PLAN AND ZONING COMMISSION MEETING

CITY OF DAVENPORT, IOWA

Case F21-11: Request of Origin Design on behalf of Russell Construction for a final plat of Russell-Frye/Armstrong Industrial Park 1st Addition for a 4-lot subdivision on 95 acres, located at 8730 Northwest Boulevard. [Ward 2]

Case P21-05: Request of Beckett Place Development, LLC on behalf of Glen and Kathleen Moeller for a Preliminary Plat of Beckett Place for a 52 lot subdivision on 25.8 acres located south of Veterans Memorial Parkway and east of Interstate 74. [Ward 6]

FINAL PLAT

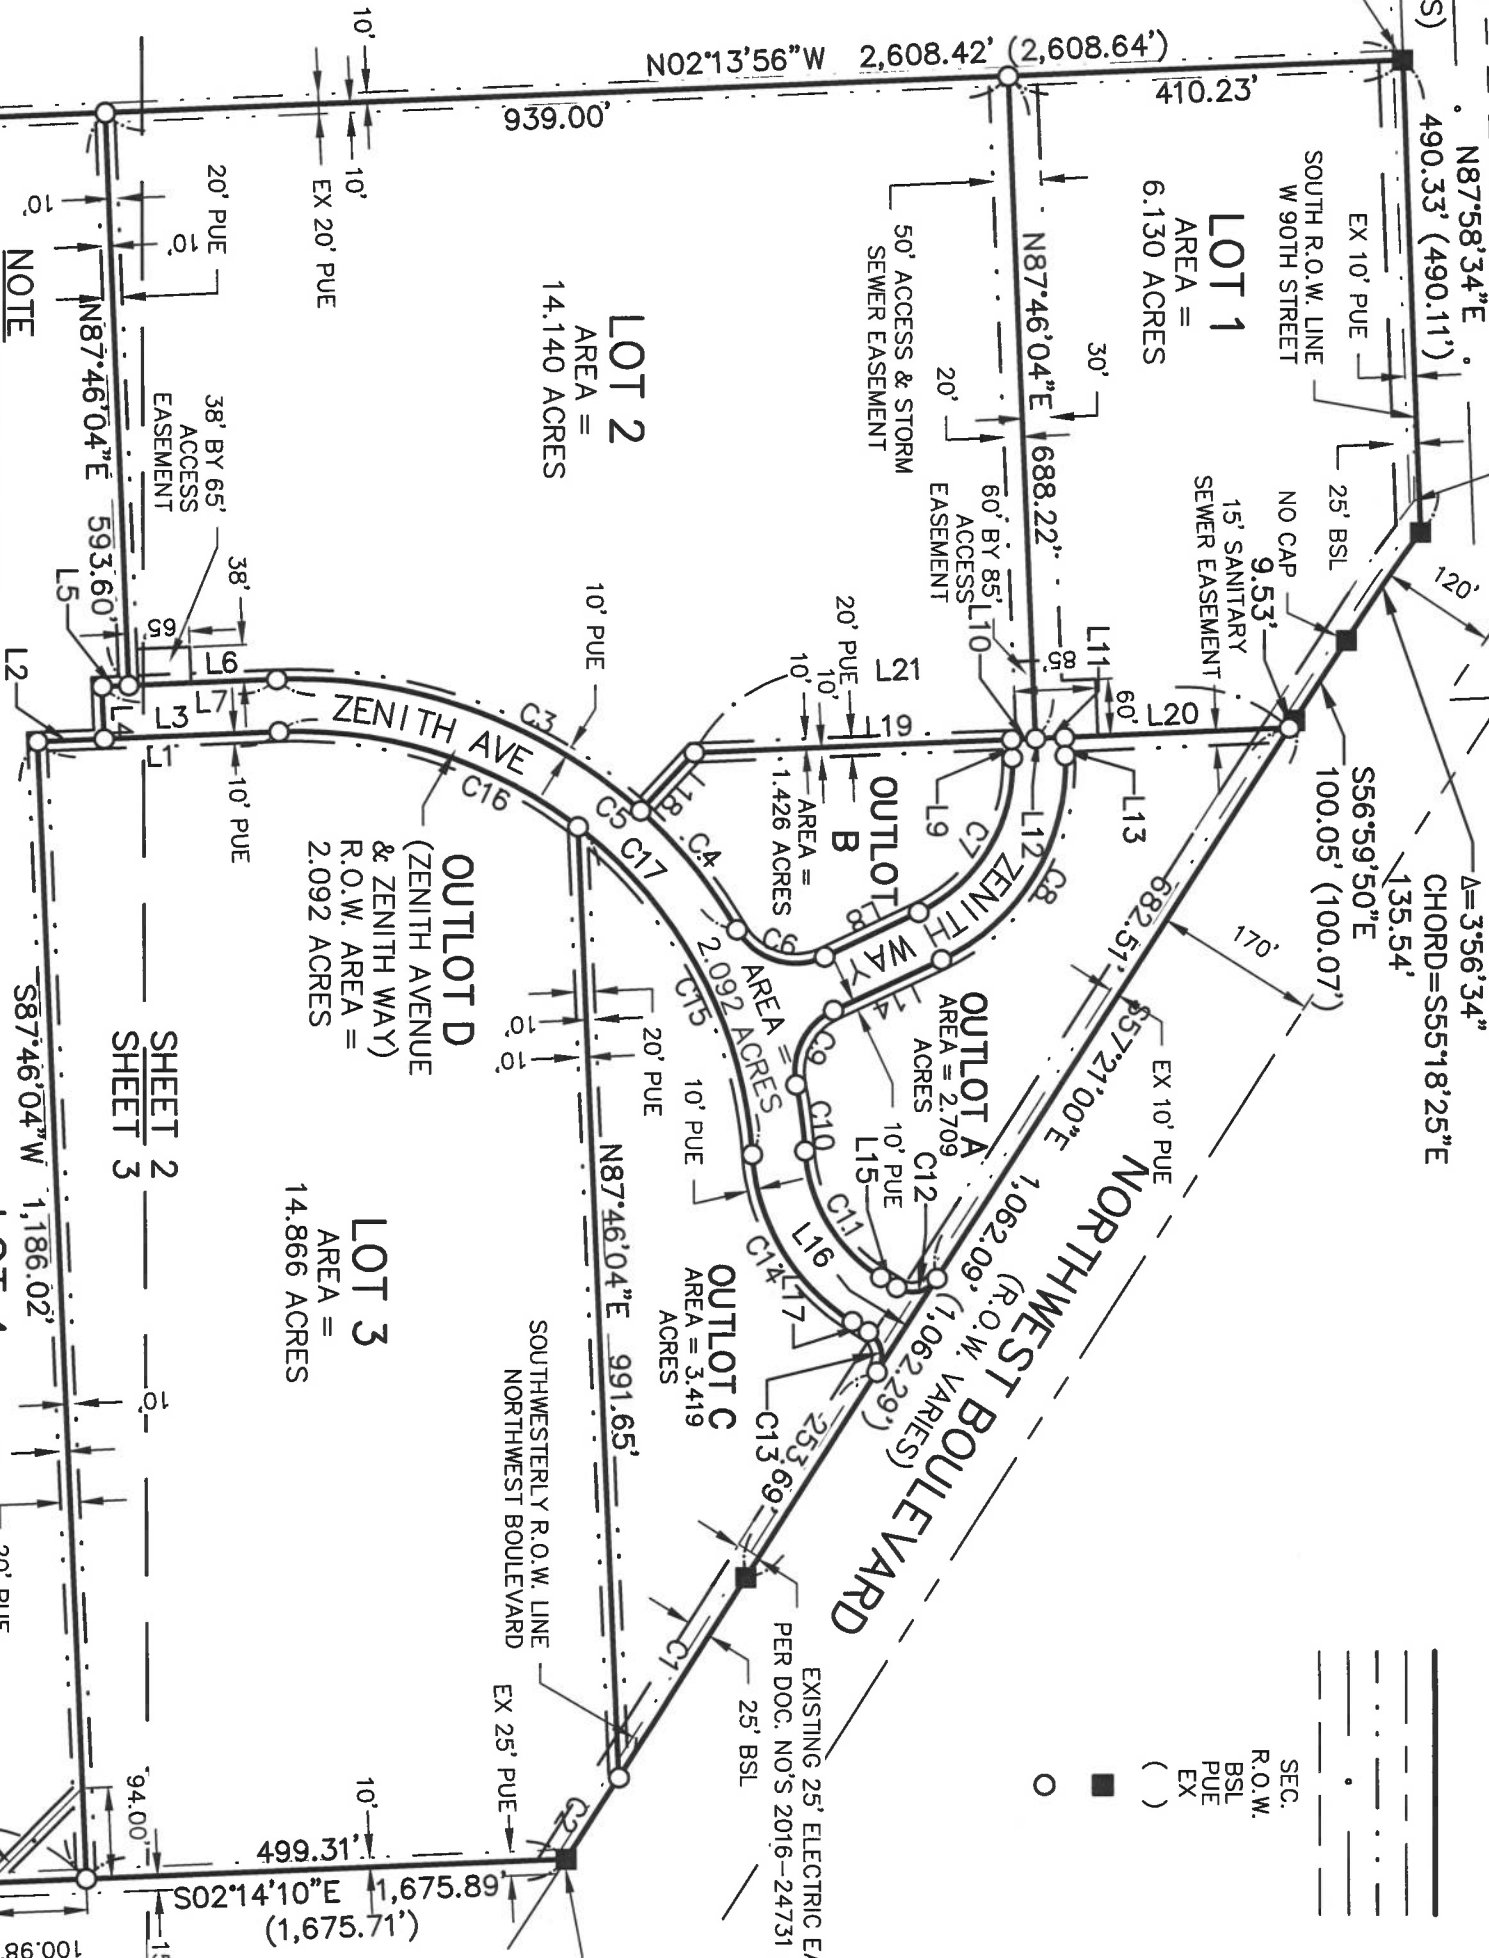
1. That the surveyor signs the plat.
2. That the utility providers sign the plat when their easement needs have been met.
3. Standard set of notes, including notes from the approved preliminary plat shall be added to the final plat.

4. Corporate limits shall be shown on the plat.
5. Public utility easements shall be a minimum of 15 feet or twice the depth of the utility line, whichever is greater.

6. Add a note stating, "Direct access from any lot onto Northwest Boulevard is prohibited."
7. Add the following note, "Access to West 90th Street shall be a minimum of 450 feet from the west right-of-way line of Northwest Boulevard."

8. All outlots shall have a description of purpose, the owner, and party responsible for maintenance on the final plat.
9. Add a note stating Zenith Avenue and Zenith Way shall be dedicated as public right-of-way on the plat. Remove the reference to "Outlot D".

10. Include a note regarding stormwater detention and water quality requirements that reads, "Stormwater detention and water quality treatment are required with this subdivision and will be subject to the applicable ordinances in place at the time of development."

11. Zenith Way shall be renamed to West 89th Street.
12. Add the directional to Zenith Avenue to read as "North Zenith Avenue".
13. Indicate the dedicated right-of-way width of Zenith Avenue.

14. Zenith Avenue requires an access easement for vehicle turnaround within Lot 3 and/or Lot 4.
15. Provide a drainage easement for stormwater runoff from the properties on the west side of the platted area. This easement must be capable of transferring the 100-year storm. Submit calculation to City staff.

PRELIMINARY PLAT
BECKETT PLACE
DAVENPORT, IOWA

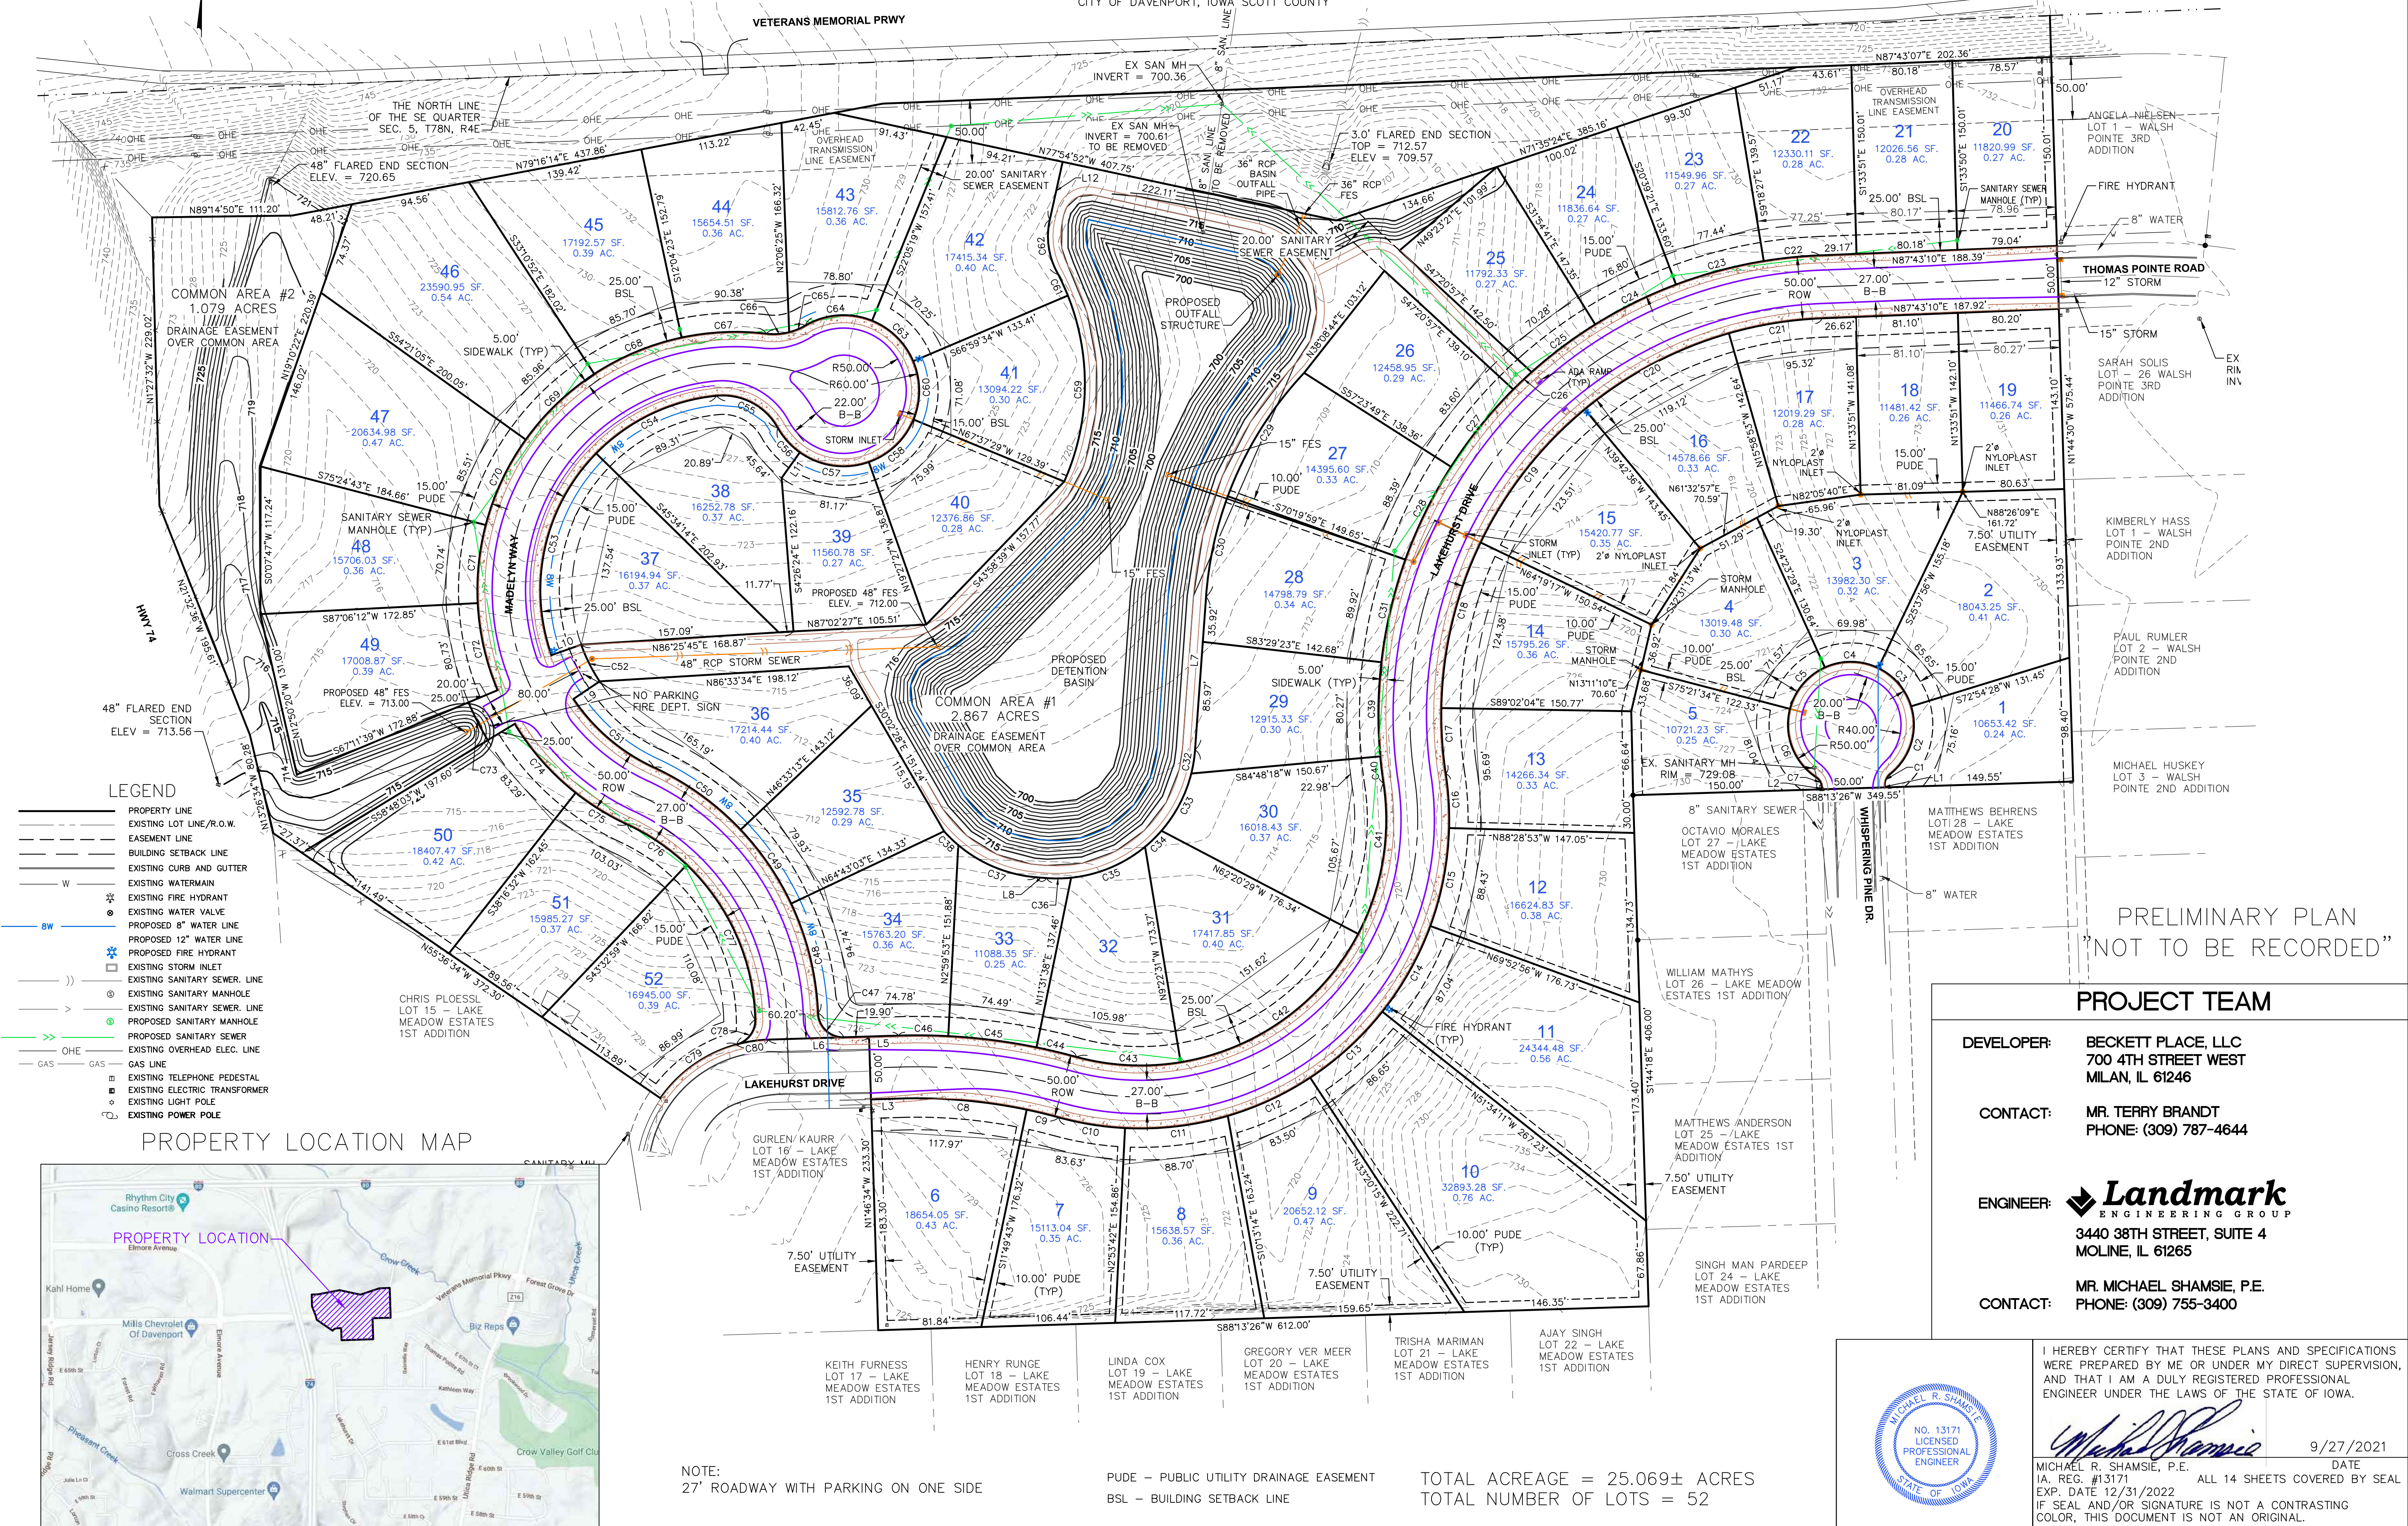
1. Exceeding maximum length of cul-de-sacs for Madelyn Way and Whispering Pine Drive.
2. Exceeding maximum block length between Madelyn Way and Gabrielle Way.

Staff supports a variance to exceed the maximum length of a cul-de-sac on Madelyn Way. However, the variance requests to exceed the maximum cul-de-sac length on Whispering Pine Drive and maximum block length on Thomas Pointe Drive, between Madelyn Way and Gabrielle Way, do not comply with the spirit and intent of the ordinance. The applicant may still subdivide the property in a reasonable manner without these two variances.

2. Storm Water: The site requires stormwater detention and shall meet water quality criteria in the Iowa Storm Water Management Manual. Storm detention is proposed in Common Areas 1 and 2, which should be relabeled as outlots. Access must be provided for maintenance of detention areas and any drainage ways must be maintained to provide for the proper flow of water. The full extent of the trail must be located within an access easement.

5. Other: This is an urban area and normal utility services are available. The public utility easement must be increased to 20 feet where water mains are planned. The fire department does not require the hammerhead turnaround midway through Madelyn Way.
